Central Market 2021/0849/FUL 2021/0850/LBC

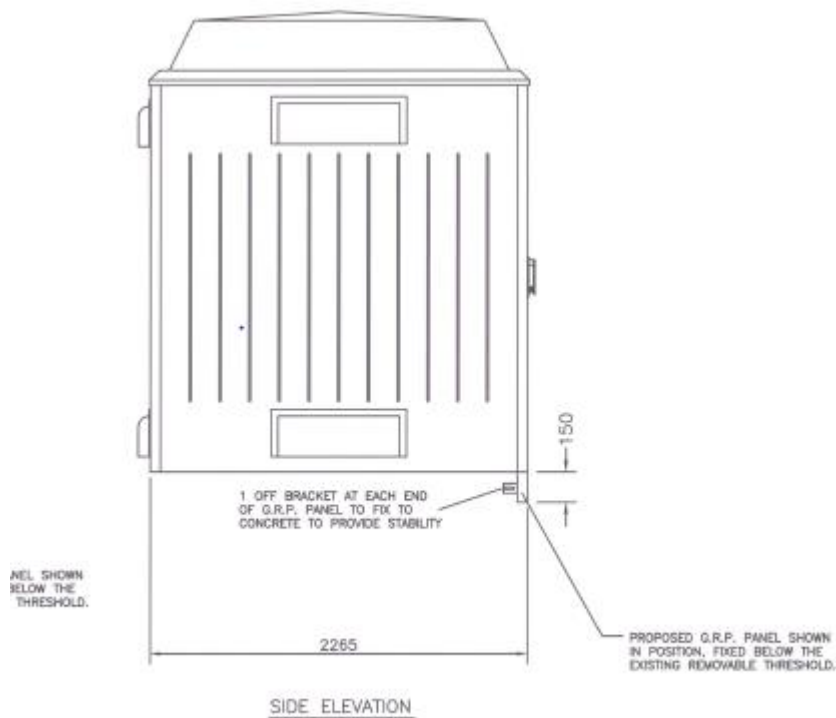
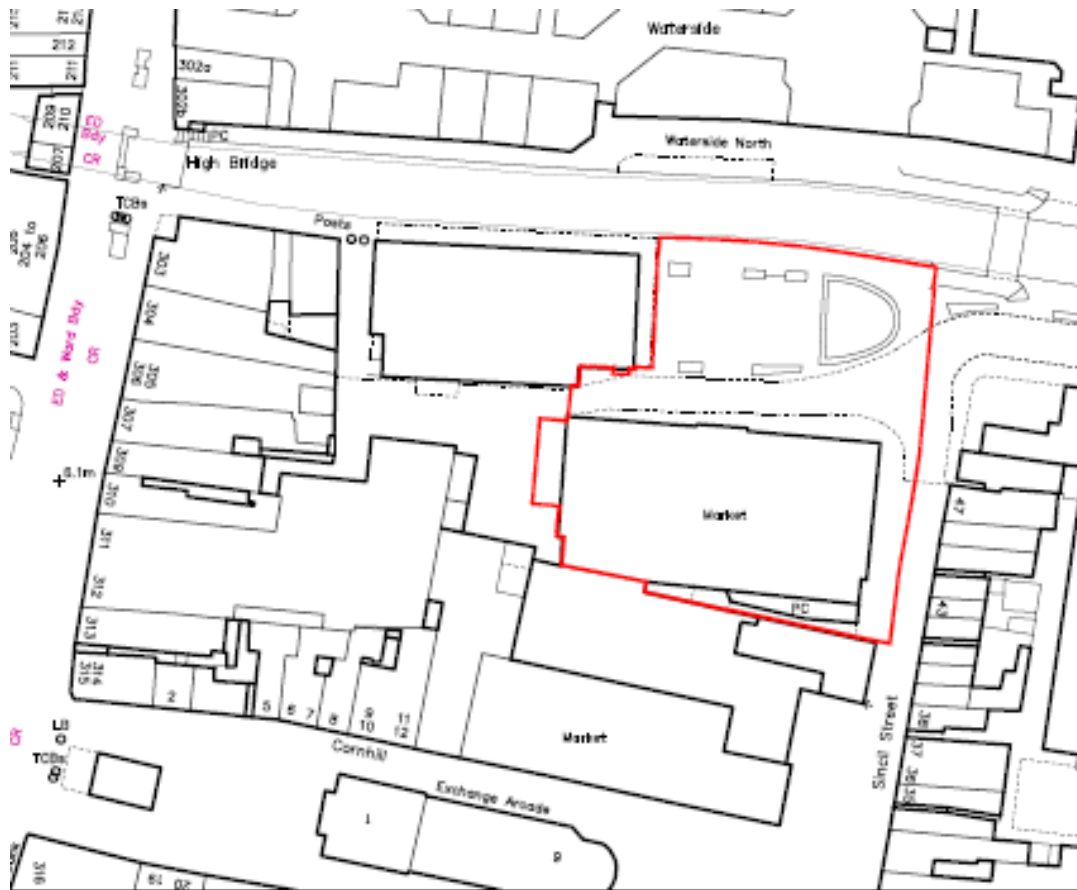
Location of the previously approved bin store. New ventilation cowl to be added to this west facing hipped section of the roof, facing the service yard.

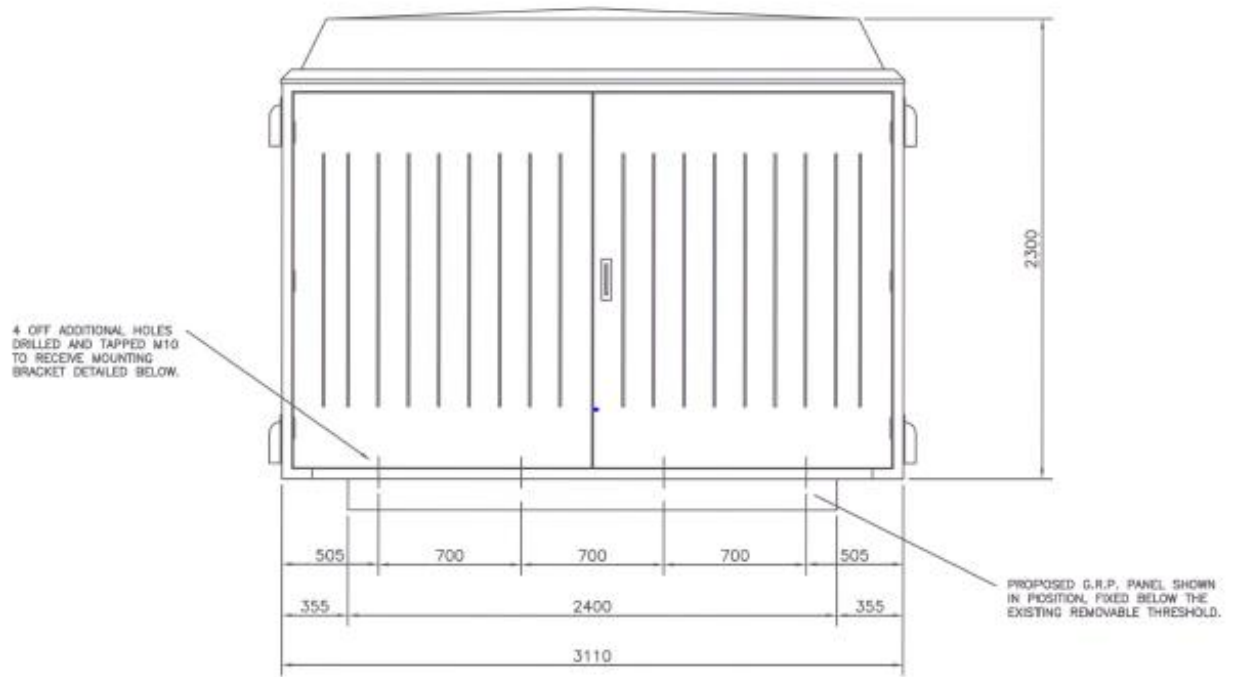
Proposed location of the new electricity sub station

Proposed sub station

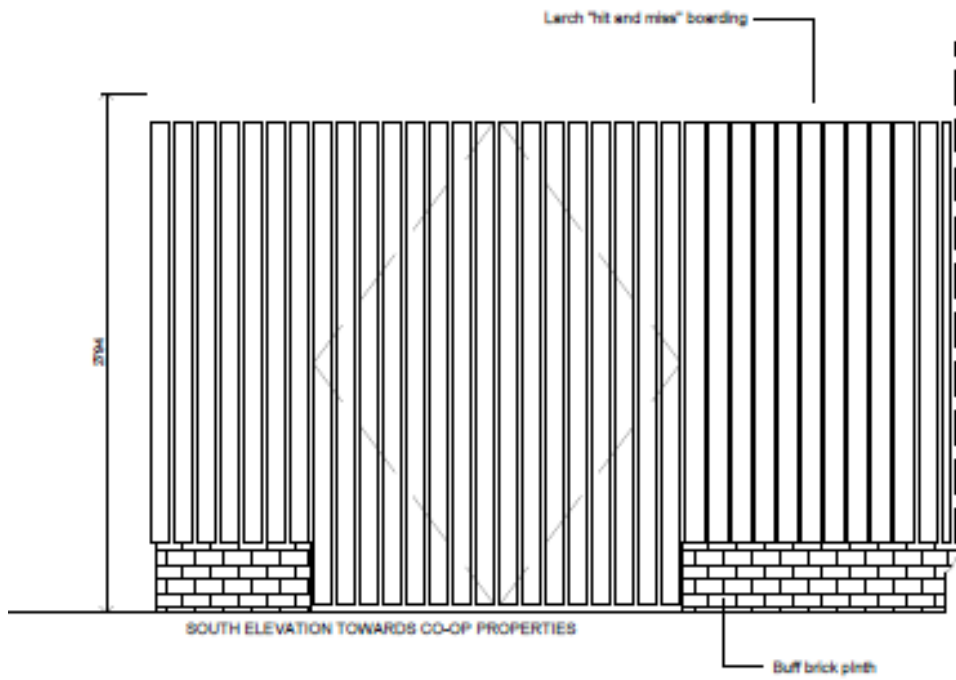
Proposed location of the new louvres to be added to the windows behind the existing black frames.

Proposed West elevation to show position of new roof cowl and sub station

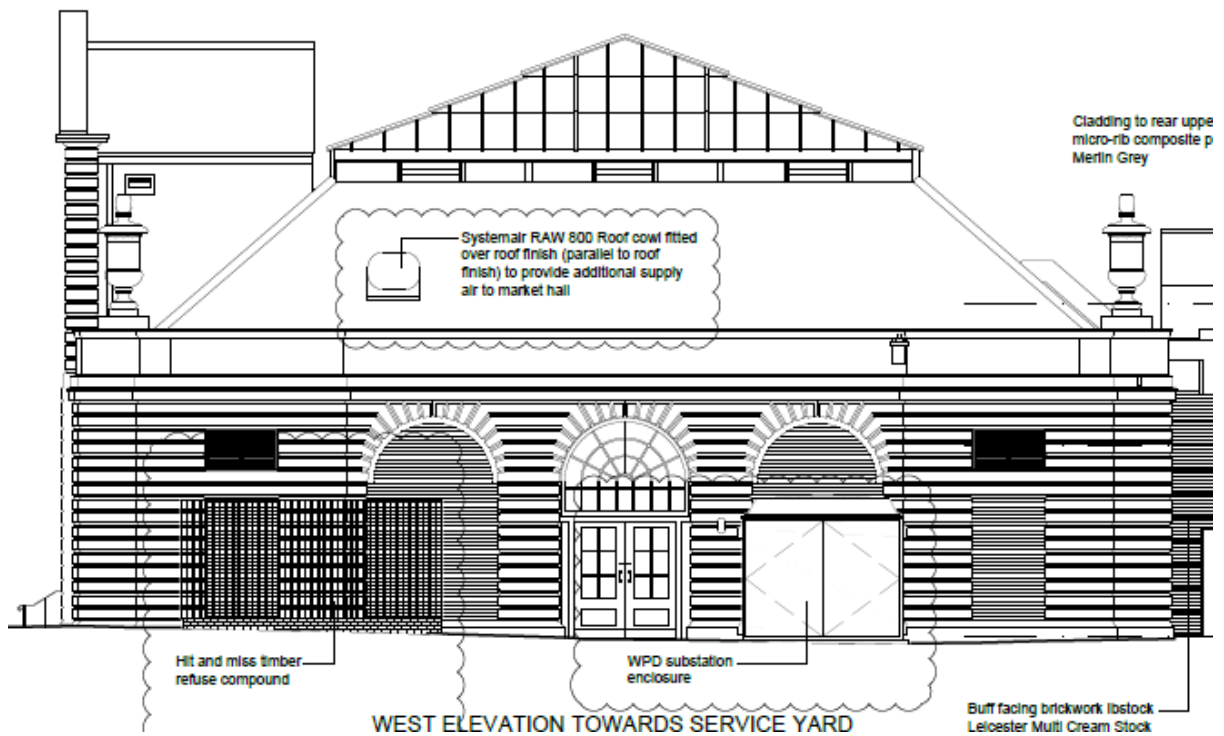
Revisions to the previously approved bin store
